$\frac{\text{MONTGOMERY COUNTY HISTORIC PRESERVATION COMMISSION}}{\text{STAFF REPORT}}$

Address: 5 Montgomery Ave., Takoma Park Meeting Date: 12/04/2024

Case Number: 1091028 Staff: Laura DiPasquale

Proposal: Hardscape alteration and fence installation

Figure 4: The proposed site plan showing the driveway and walkways (solid red lines) and staff-recommended modification (blue line).

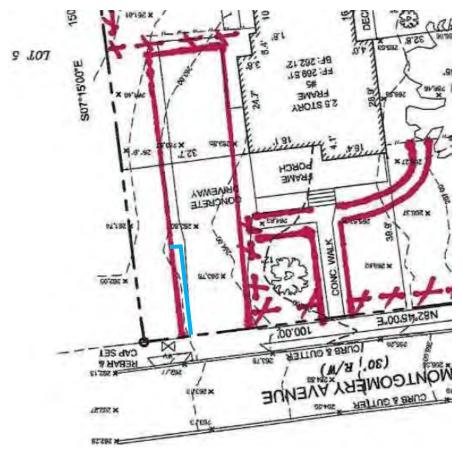
Staff notes, however, that the proposed 20-foot wide pervious driveway is unusually wide for properties in the Takoma Park Historic District, where double-wide driveways with access from the primary façade are typically shared between two adjacent properties. Staff recommends that the driveway extend no wider than the width of the curb cut minus the apron until reaching the front edge of the walkway leading to the front porch (approximately 20 to 22 feet from the sidewalk), at which point the driveway could widen to the full 20-foot width. This modification would allow the proposal to retain "compatibility with existing patterns" of the streetscape per the *Design Guidelines*.

Figure 6: The approximate location of the new front corner of the driveway (red arrow). Staff recommends the existing driveway width (16-18 feet wide) be maintained for the first 20-22 feet before expanding to the full 20 foot width.

1. The existing width of the driveway opening (approximately 16 feet) must be maintained for the first 20 feet from the sidewalk before widening to the full 20-foot width for the parking area.

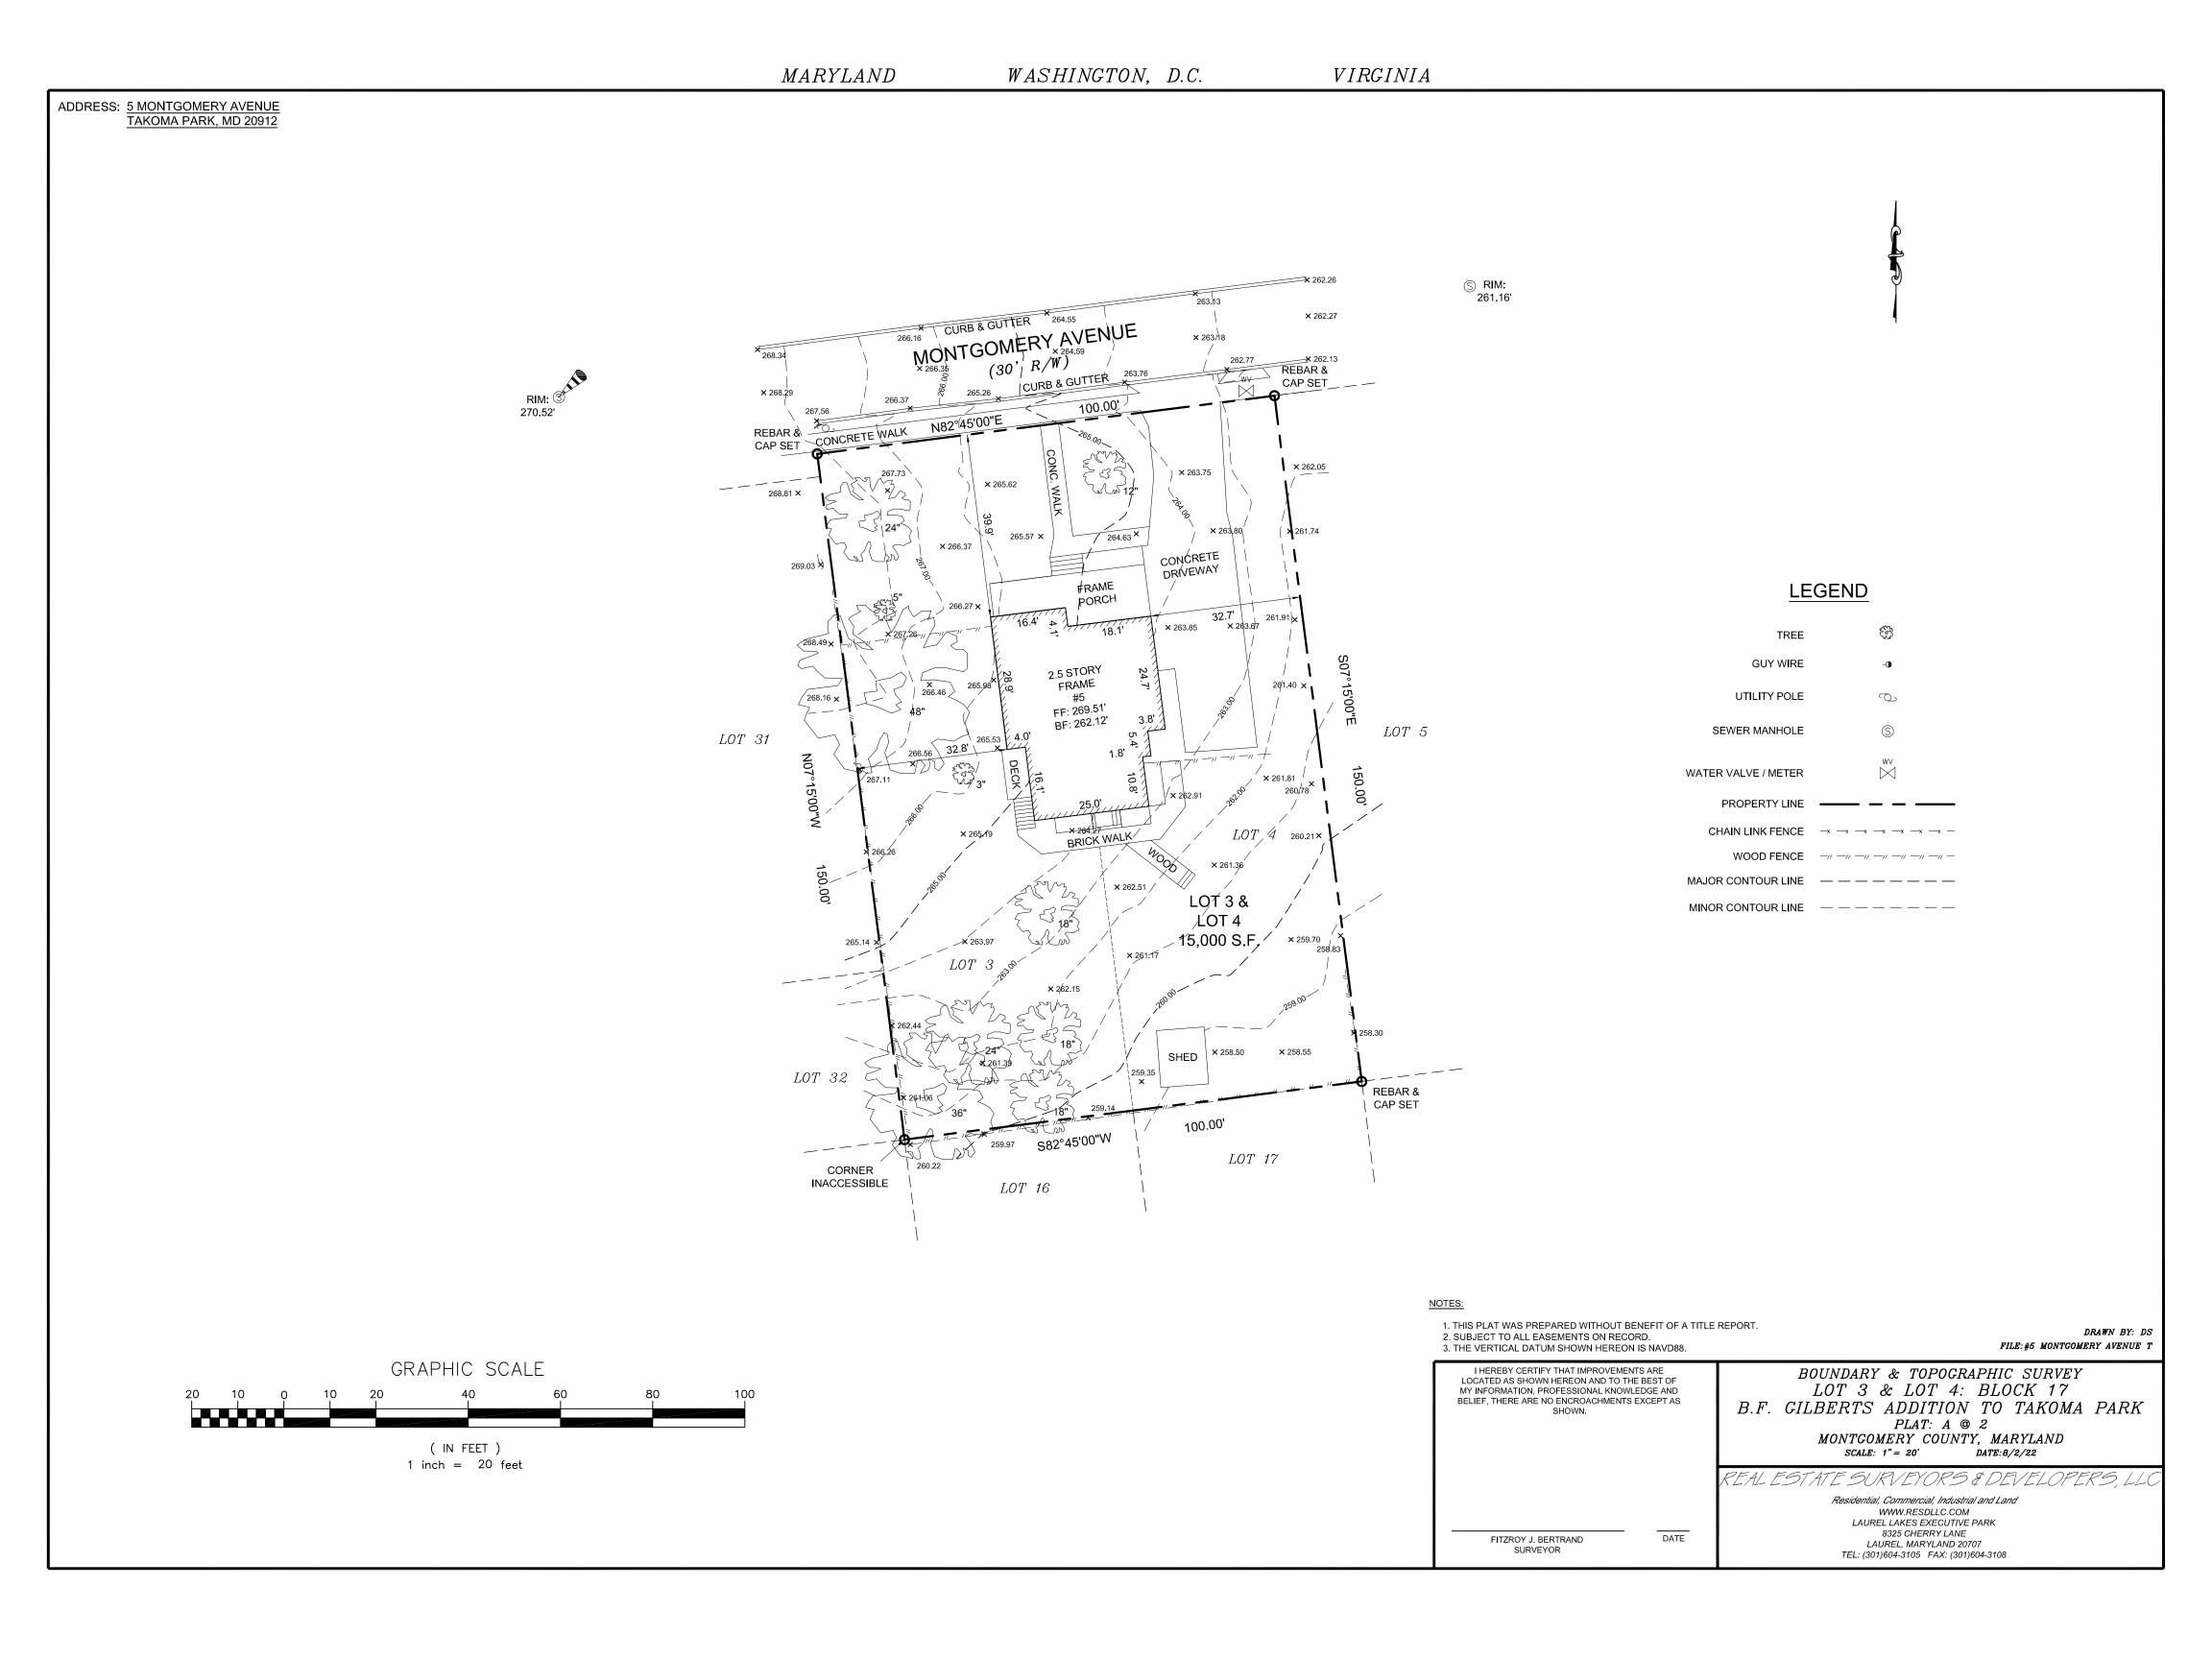
The applicant proposes to remove the existing 16-18 foot wide concrete driveway and install a new 20-foot wide blue stone gravel base with cobble paver border. Staff finds the proposed removal of impervious paving an improvement to the property and district, and that the proposed materials are compatible with the resource and the district. The application also removes the paving immediately adjacent to the house to allow for a planter bed, which staff finds is also an improvement to the existing condition.

1. The existing width of the driveway opening (approximately 16 feet) must be maintained for the first 20 feet from the sidewalk before widening to the full 20-foot width for the parking area;
